Re: Building 200, 300 and 800 Modernization  
RFP No 20-21-18  
Addendum #4

**Project: BUILDING 200, 300 and 800 MODERNIZATION**

Project Title  
**IMPERIAL VALLEY COLLEGE  
 BUILDING 200, 300 AND 800 MODERNIZATION**

Document Date	Project Number
	09-13-19	19-121V
	Date Last Revised	Reference Sheet
01-20-21	AD-1_A23	
06-17-21	Sheet Number	
	AD-4_A23

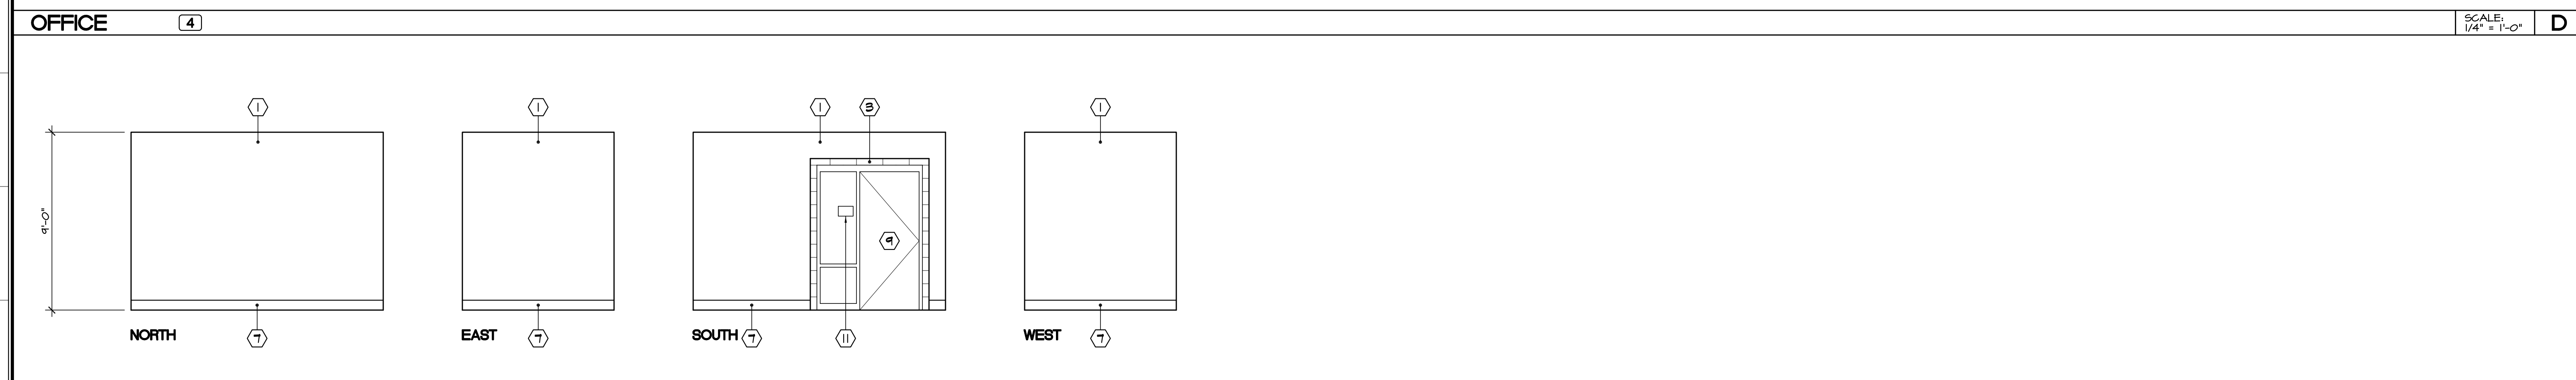
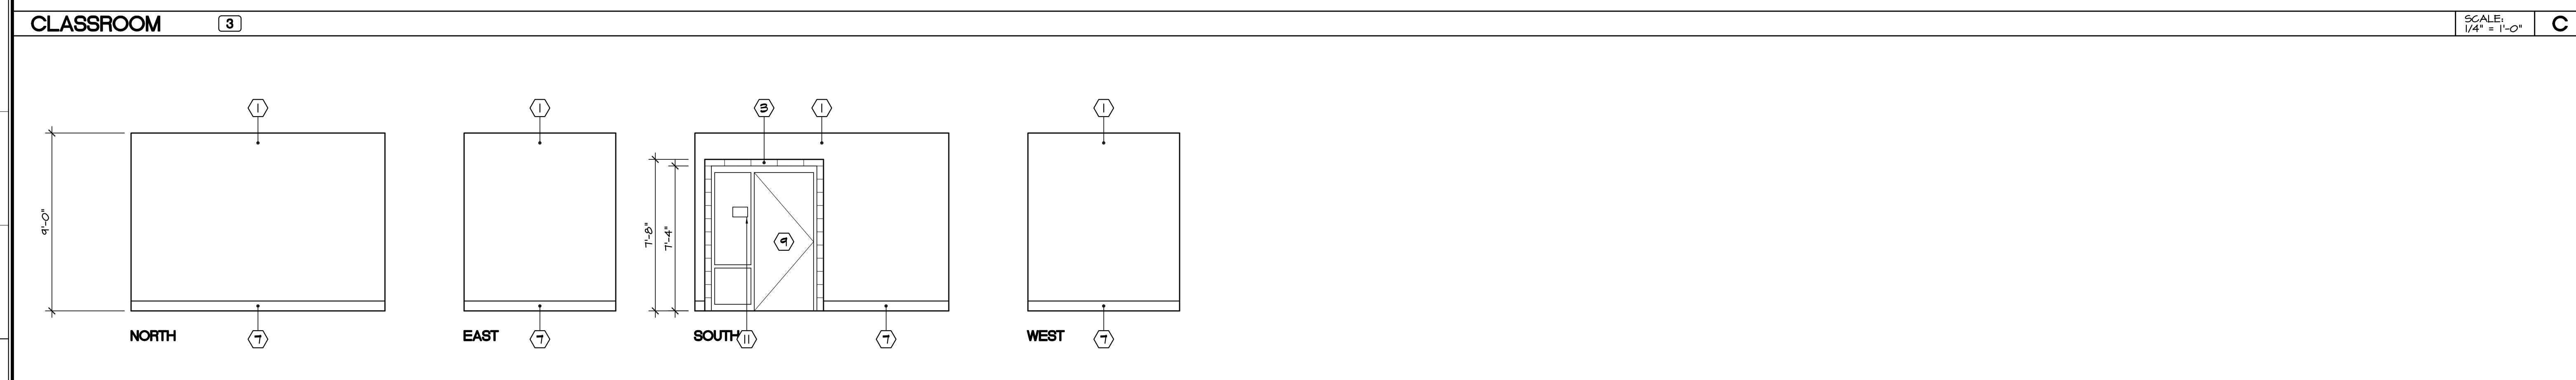
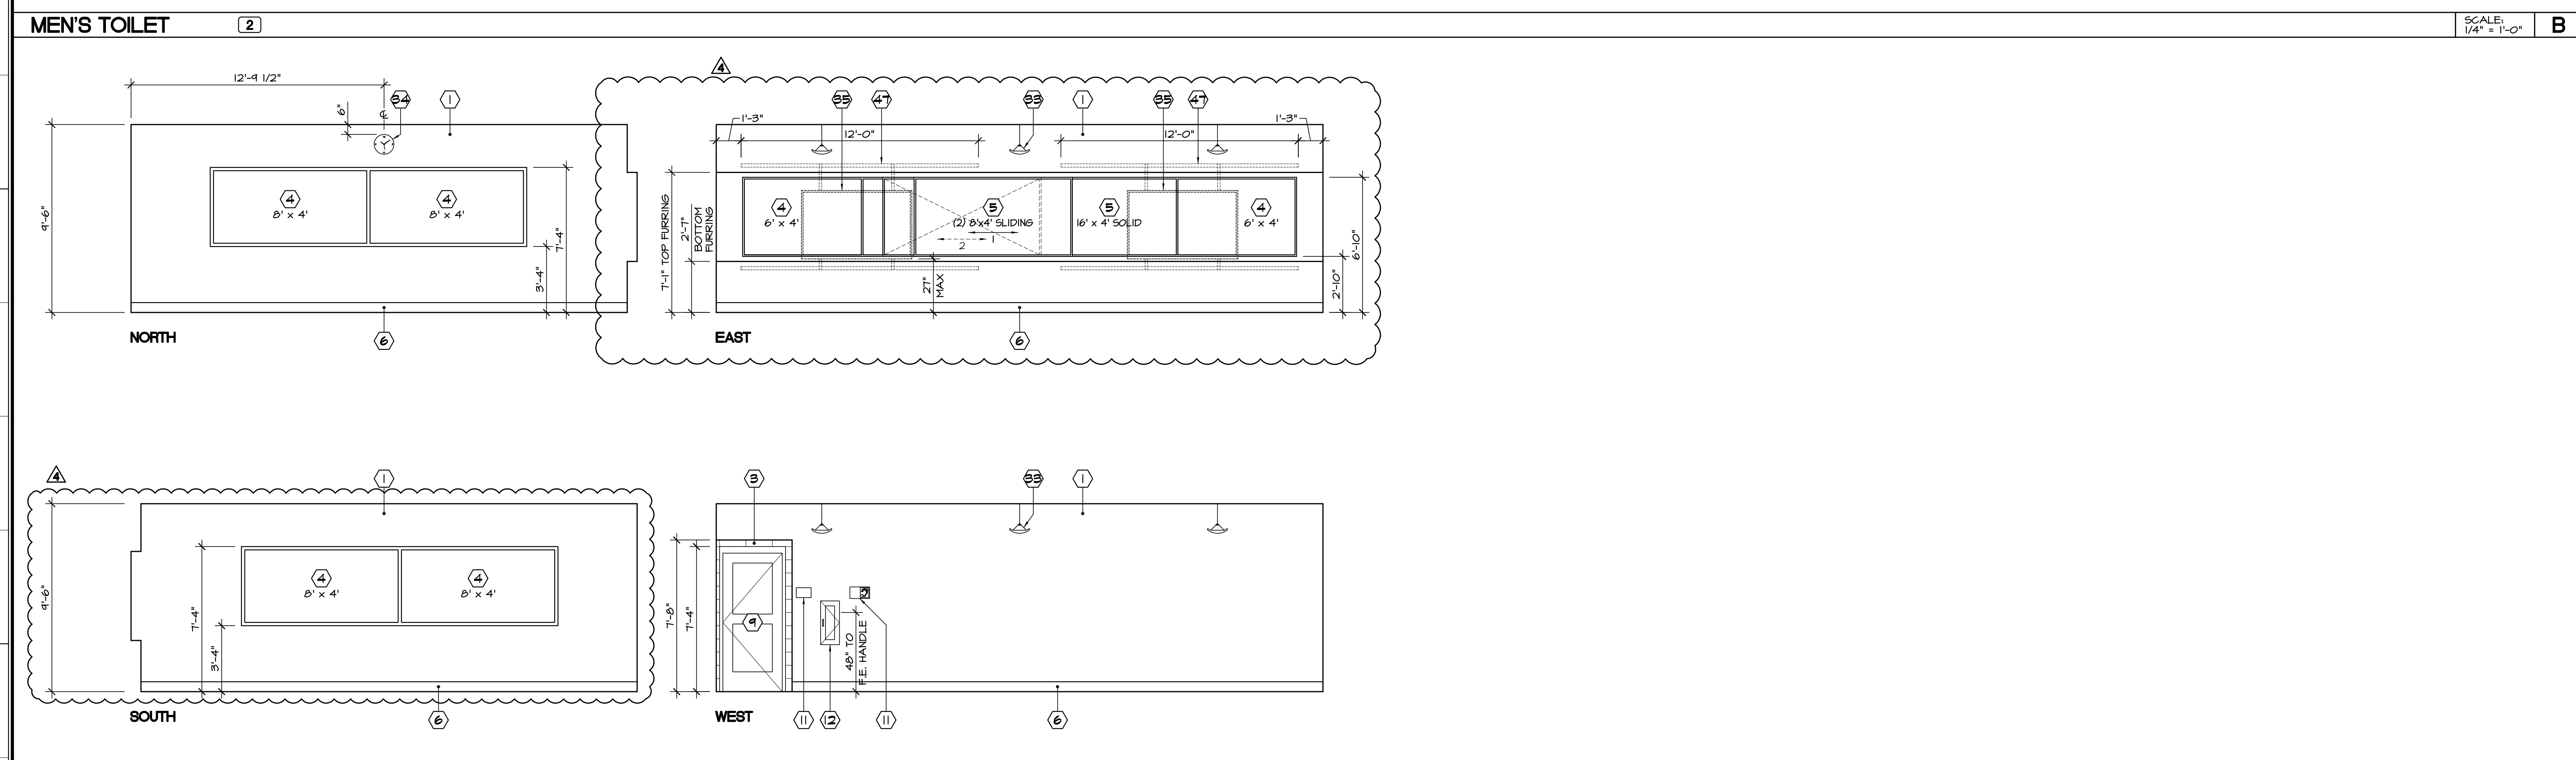
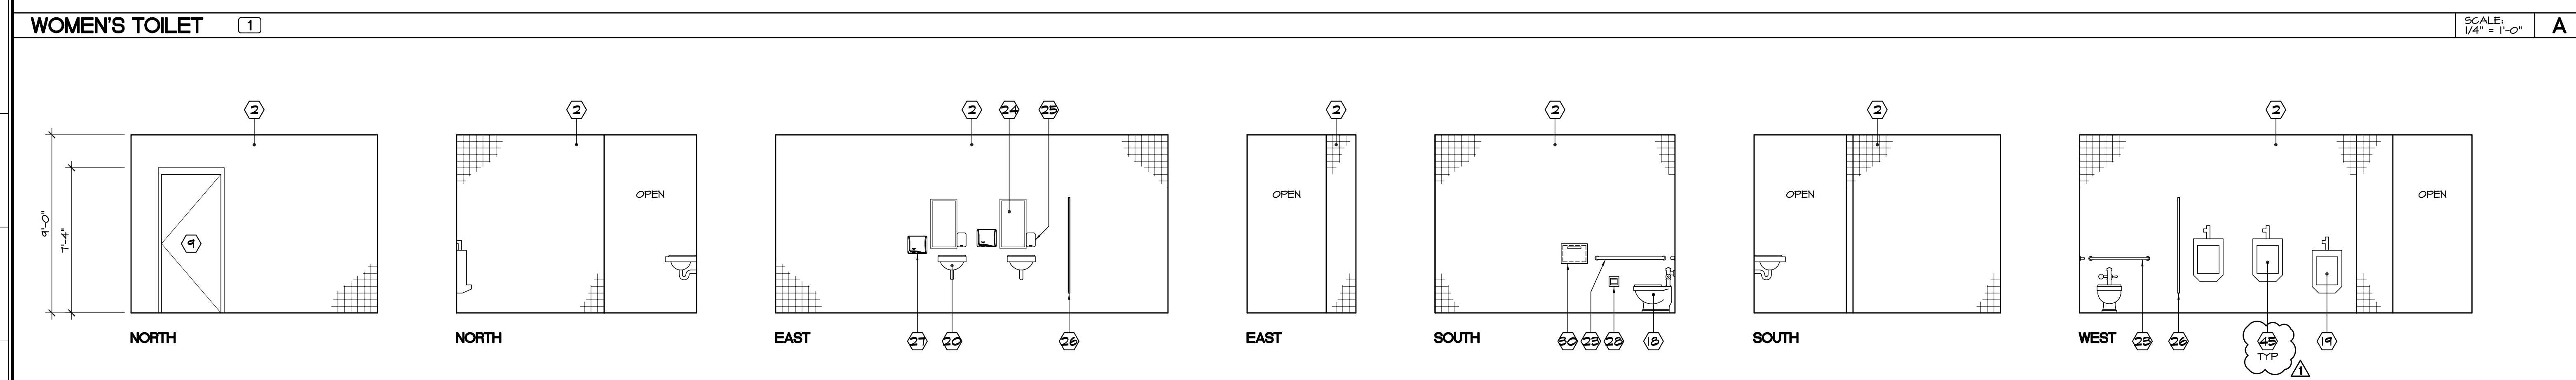
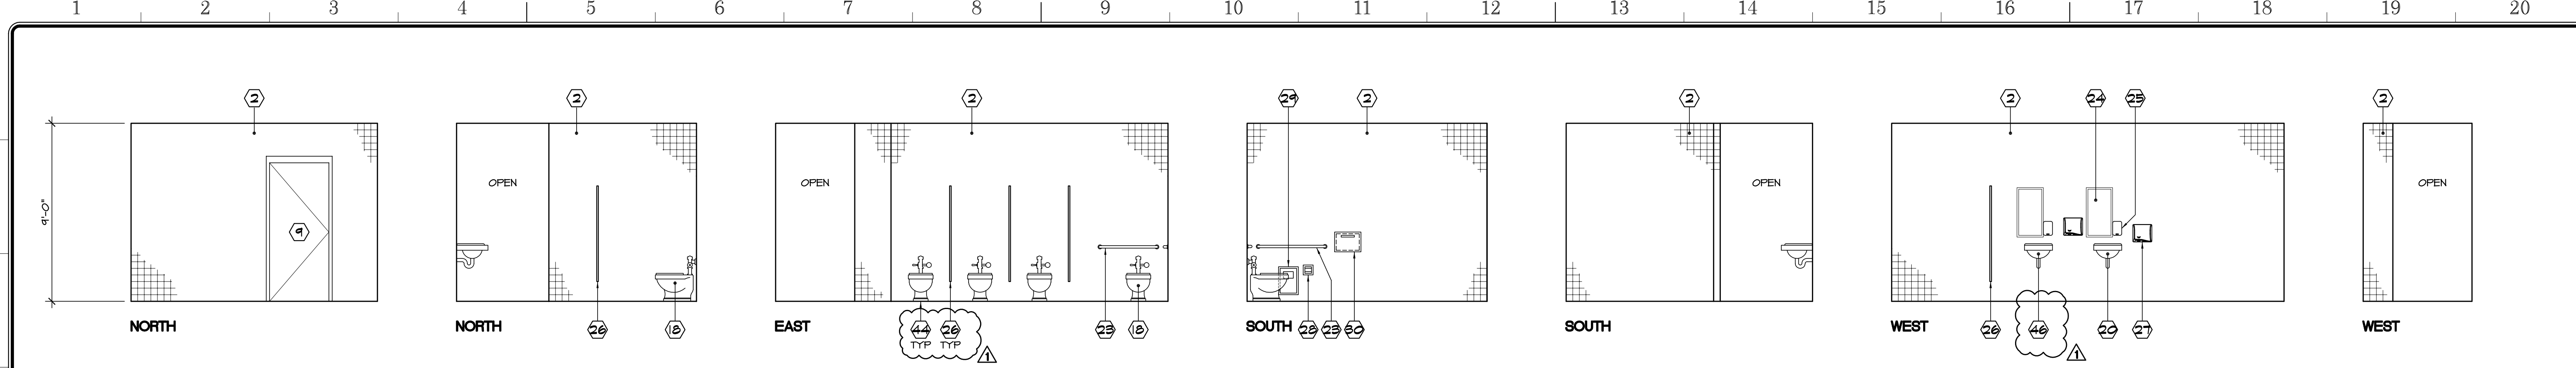
8. SHEET AD-1\_A2.3 – REFLECTED CEILING PLAN
    - a. Sheet AD-1\_A2.3 shall be replaced by Drawing AD-4\_A2.3 attached to this addendum: changes are clouded.

Document Date	Project Number
	Date Last Revised	Reference Sheet
	Date Last Revised	Sheet Number
09-13-19	19-121V	
01-20-21	<b>AD-1_A2.41</b>	
06-17-21	<b>AD-4_A2.41</b>

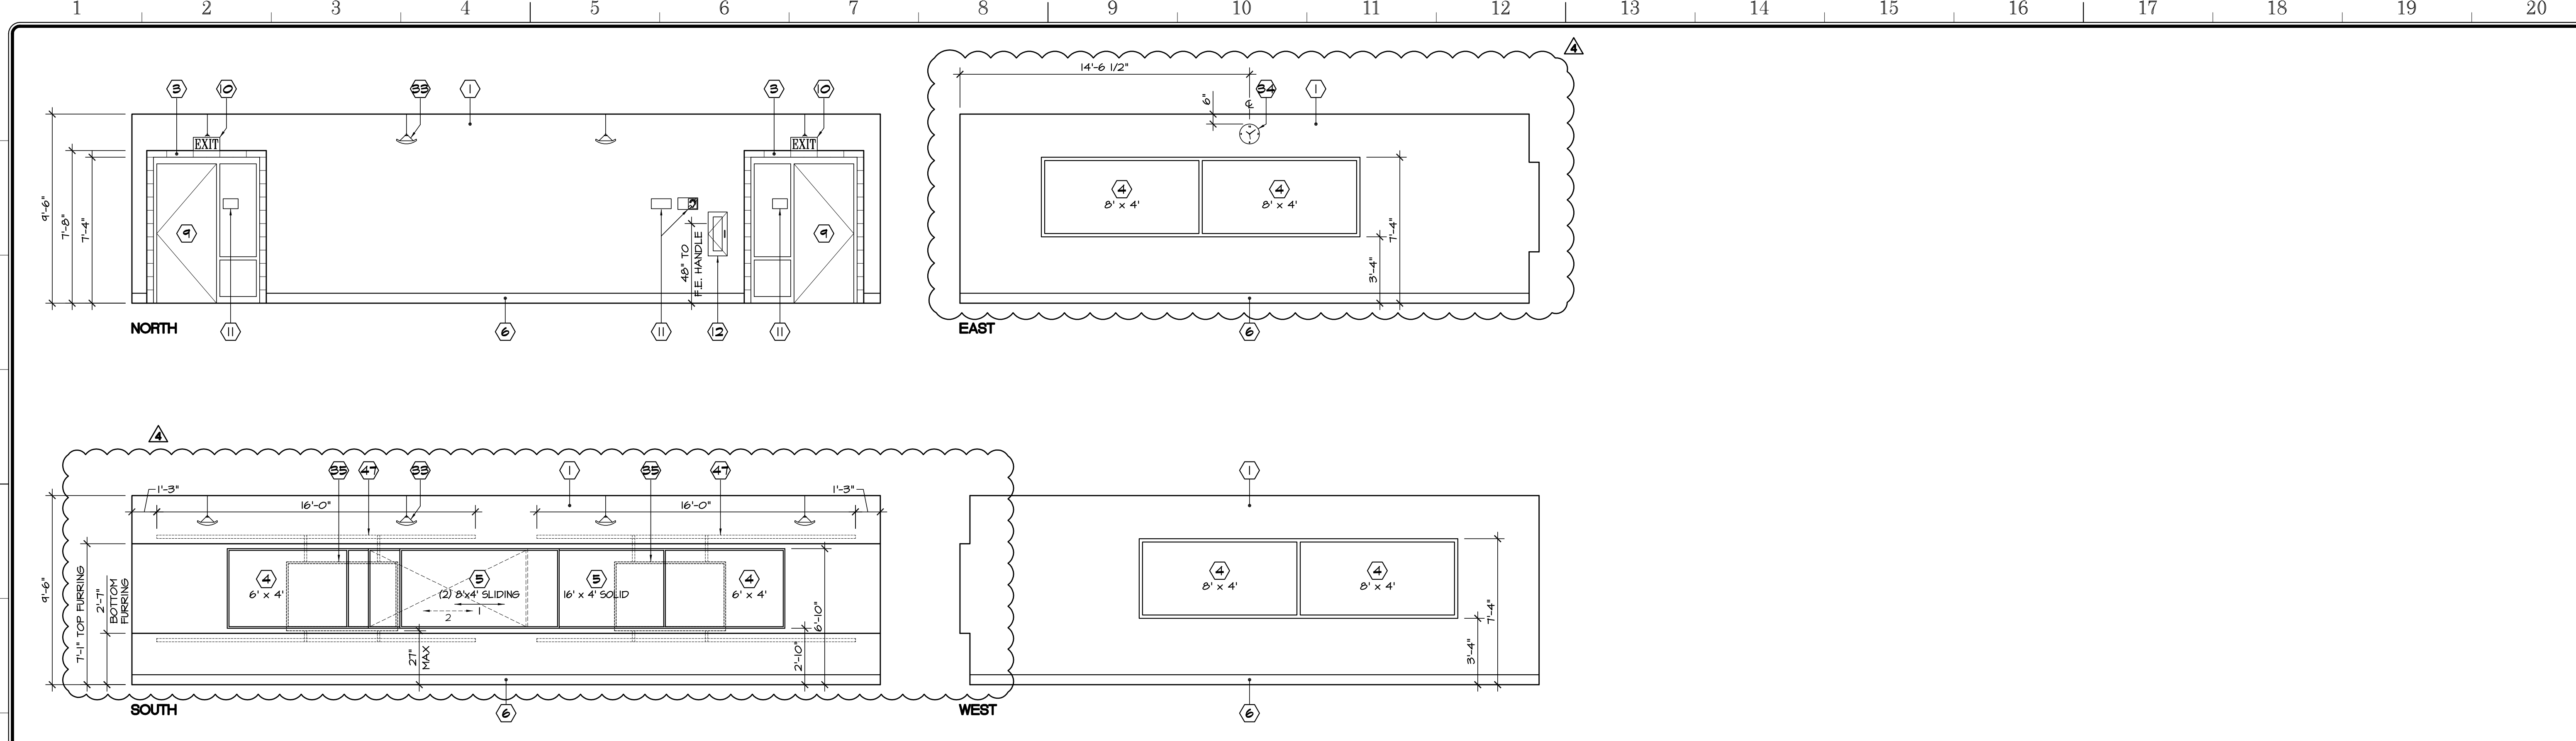
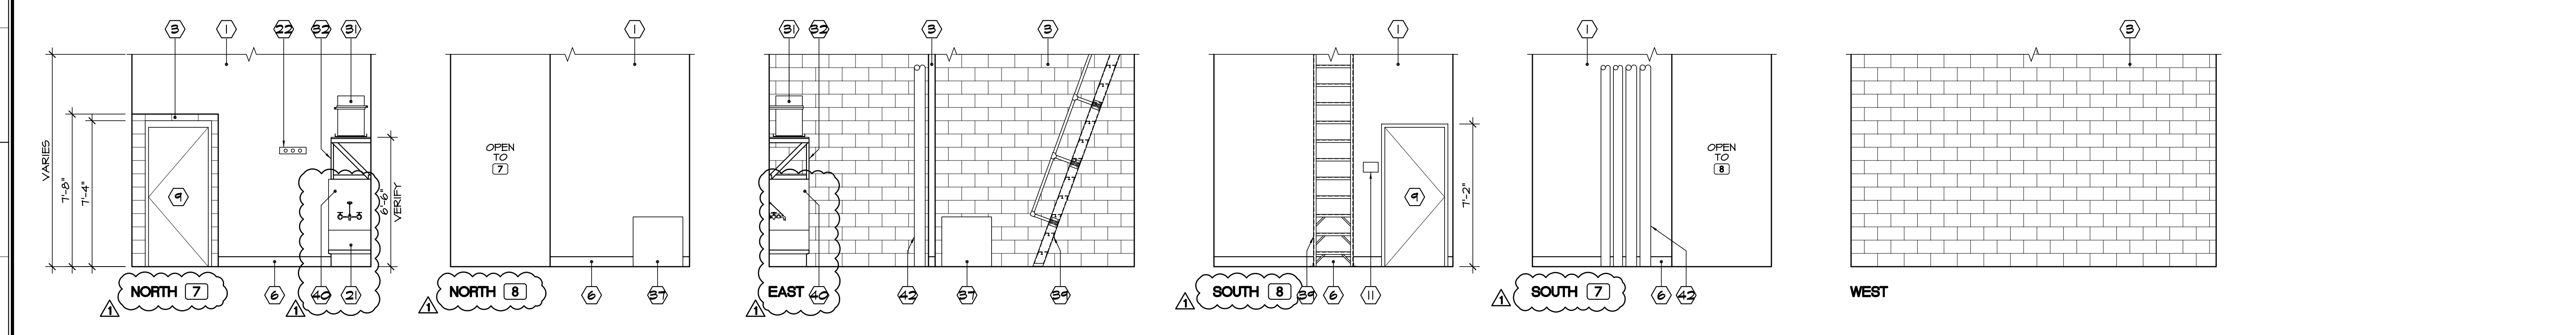
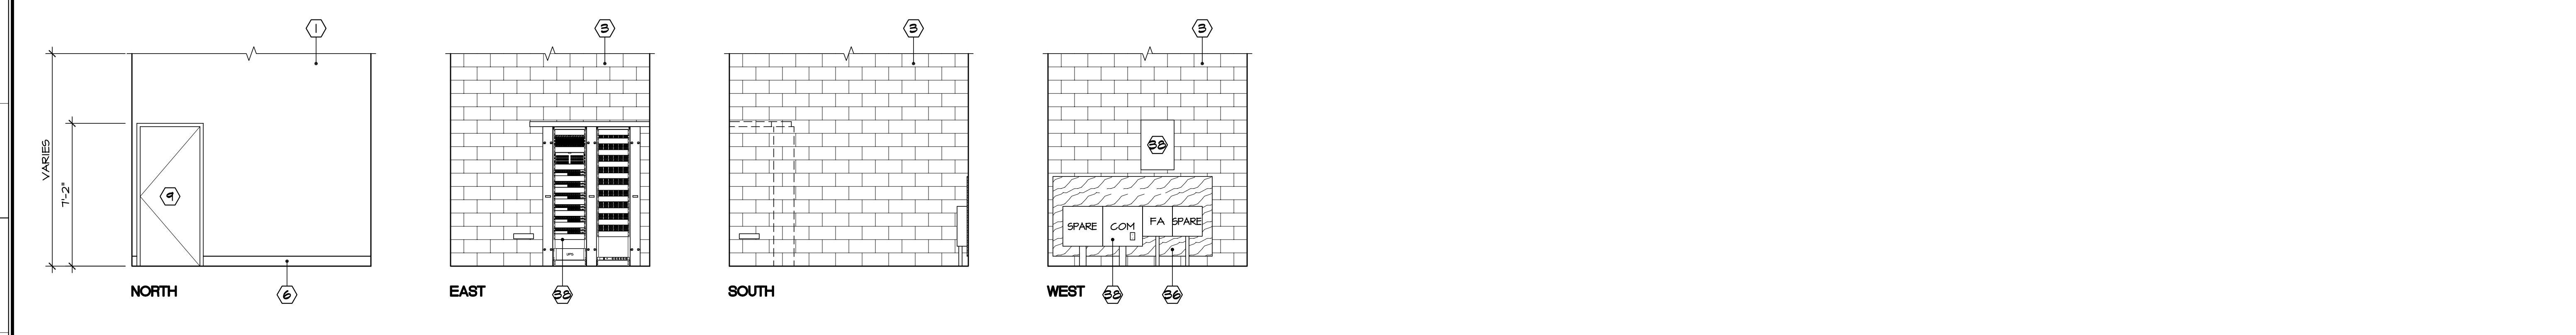
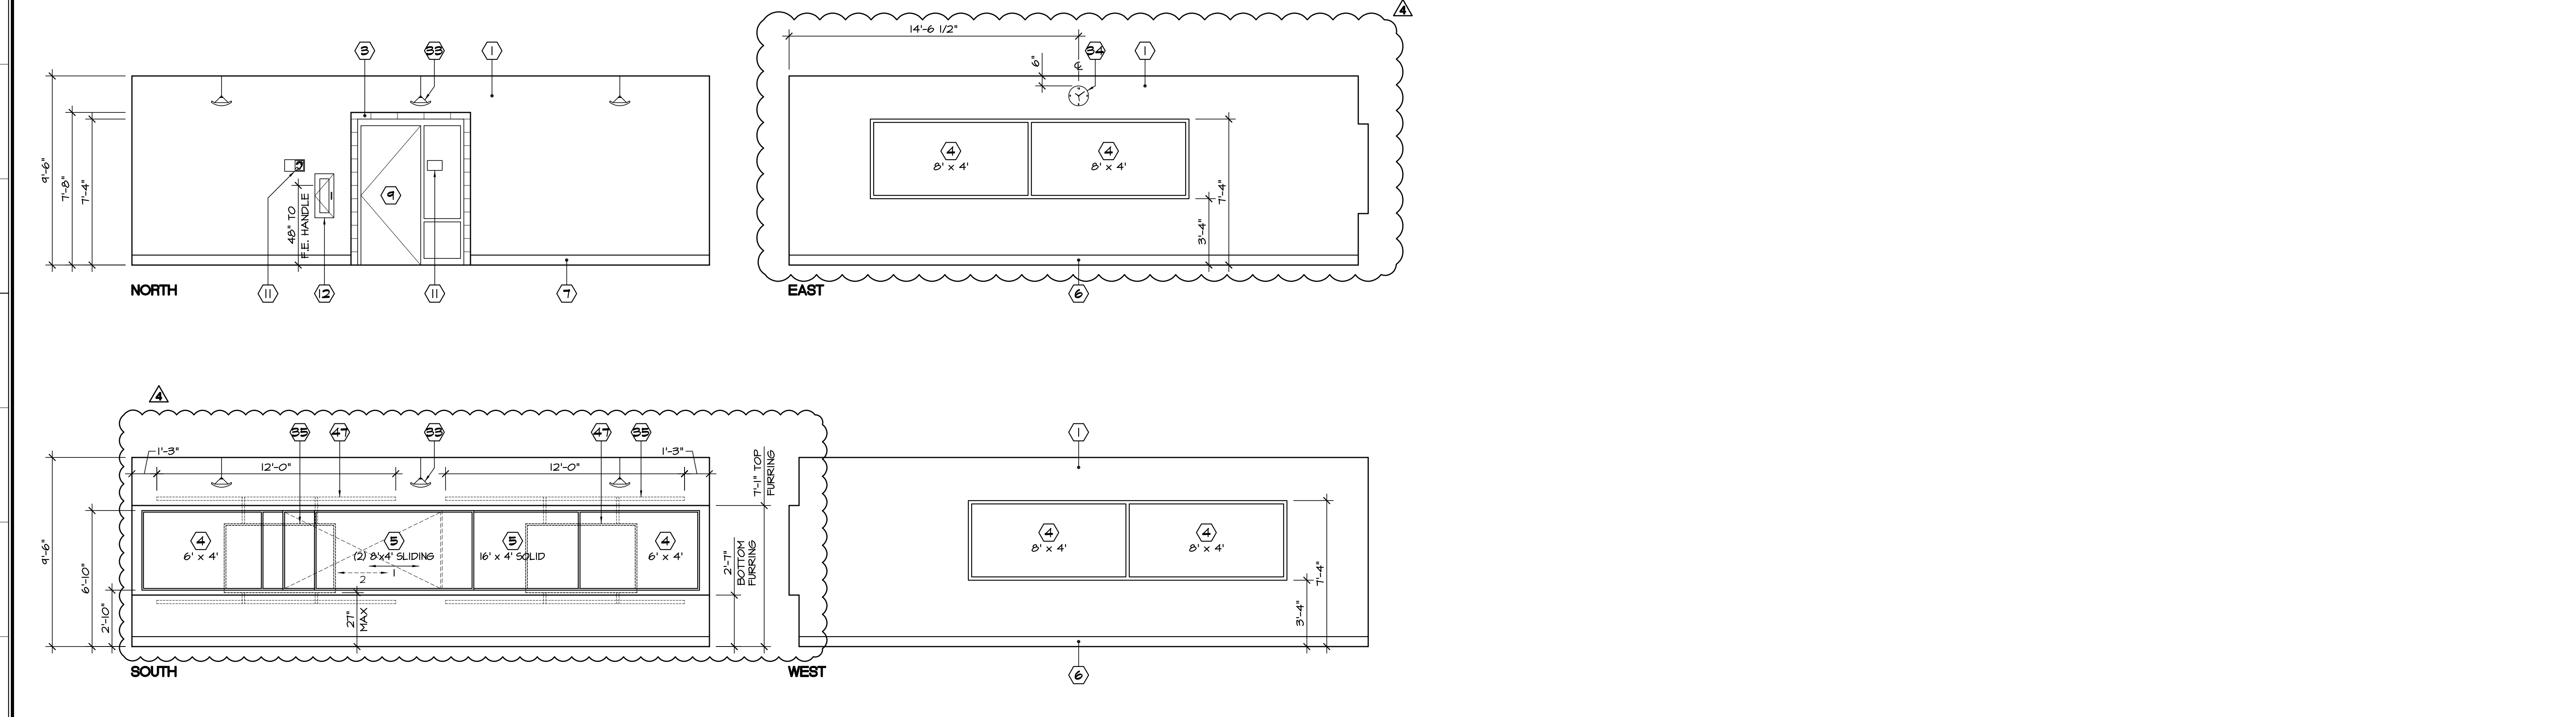
9. SHEET AD-1\_A2.4.1 – INTERIOR ELEVATIONS
    - a. Sheet AD-1\_A2.4.1 shall be replaced by Drawing AD-4\_A2.4.1 attached to this addendum: changes are clouded.
